UKWIN'S D7 COMMENTS ON REP6-025, REP6-029 & REP6-030

Medworth EfW CHP

**Land on the Algores Way Industrial Estate to the west
of Algores Way in Wisbech, Fenland, Cambridge**

EN010110

UNSUITABLE WASTE IN APPLICANT REP5-020 TABLE 4.2 HIC 2021 ARISING TABLE

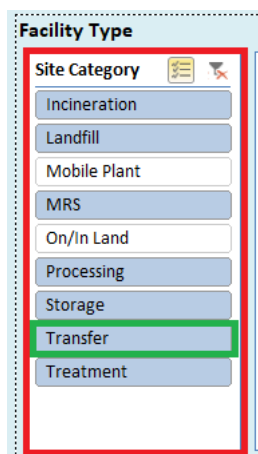
36. This ~9.7Mt figure relates to the result of 9,706,427 in REP5-020 Table 4.2.
37. However, an assessment of the HIC listed in the D5 WFAA in Table 4.2 of REP5-020 using the WDI Guide to help understand the approach adopted by the Applicant indicates that a vast majority (at least around 75%) of this 9.7Mtpa does not in fact represent HIC waste within the spatial scope of the WFAA that would be "suitable for processing at the Proposed Development".

38. While the detailed assessment is set out later in this submission (including in the Technical Annex at the end), the results are summarised below.

39. This indicates that at least around 75% of the Applicant's 9.7Mt HIC waste figure identified by the Applicant in REP5-020 Table 4.2 is waste that is clearly unsuitable for inclusion as potential incinerator feedstock.
